Access Compliance Report

Public Rights-of-Way

(Curb Ramps)

Intersection ID: 12809	Main Street: N_MCDOWELL_ST	Cross Street: E_7TH_ST	Location: W
ADA ID: 7937B94A3B59	Ramp Type: PerpDiag	Initial Pass/Fail: Fail	Overall Compliance: No
Severity Score: 46.25			
Codes/Mitigation Info/Possible Solution		Field Measurements/Component Compliance

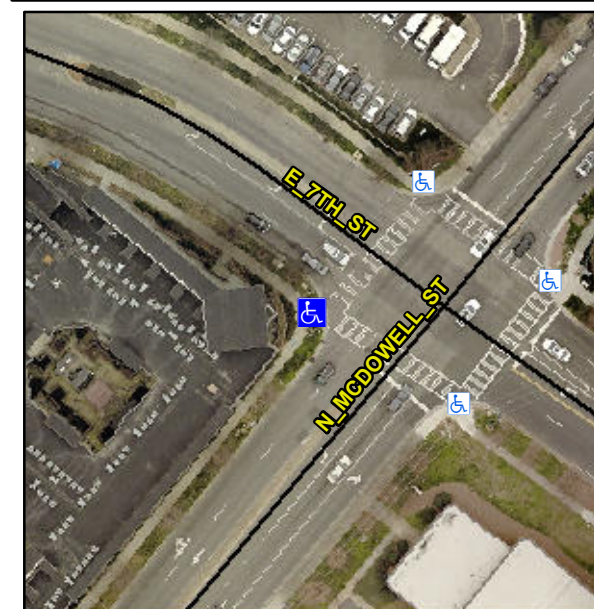
Not Found, R304.5.1, R304.2.2, R304.5.3

Compliance	Description	Data	Compliance	Description	Data
N/A	Ramp Length (in)	96.0	No	Ramp Slope (%)	8.8
No	Ramp Width (in)	38.0	No	Ramp XSlope (%)	8.3
N/A	Flare Type LT	N/A	N/A	Flare Type RT	N/A
N/A	Flare Slope LT (%)	N/A	N/A	Flare Slope RT (%)	N/A
N/A	Flare Traversable LT?	N/A	N/A	Flare Traversable RT?	N/A
N/A	Landing Length (in)	N/A	N/A	DWS Provided?	N/A
N/A	Landing Width (in)	N/A	N/A	DWS Contrast?	N/A
N/A	Landing Slope (%)	N/A	N/A	DWS Length (in)	N/A
N/A	Landing X Slope (%)	N/A	N/A	DWS Full Width?	N/A
N/A	Landing Curb? (Y/N)	N/A	N/A	DWS Offset (in)	N/A
N/A	Shared Landing?	N/A			
N/A	Gutter Ponding?	N/A	N/A	Gutter Slope (%)	N/A
N/A	Gutter Lip Ht (in)	N/A	N/A	Gutter X Slope (%)	N/A
N/A	Painted X Walk1?	Yes	N/A	Painted X Walk2?	Yes
	X Walk 1 Direction	To SE		X Walk 2 Direction	To NE
N/A	X Walk 1 Width (in)	111.0	N/A	X Walk 2 Width (in)	110.0
	X Walk 1 Slope (%)	2.0		X Walk 2 Slope (%)	3.5
	X Walk 1 X Slope (%)	2.9		X Walk 2 X Slope (%)	2.5

Remove & Replace Curb Ramp With Two New Directional Ramps or Equivalent.
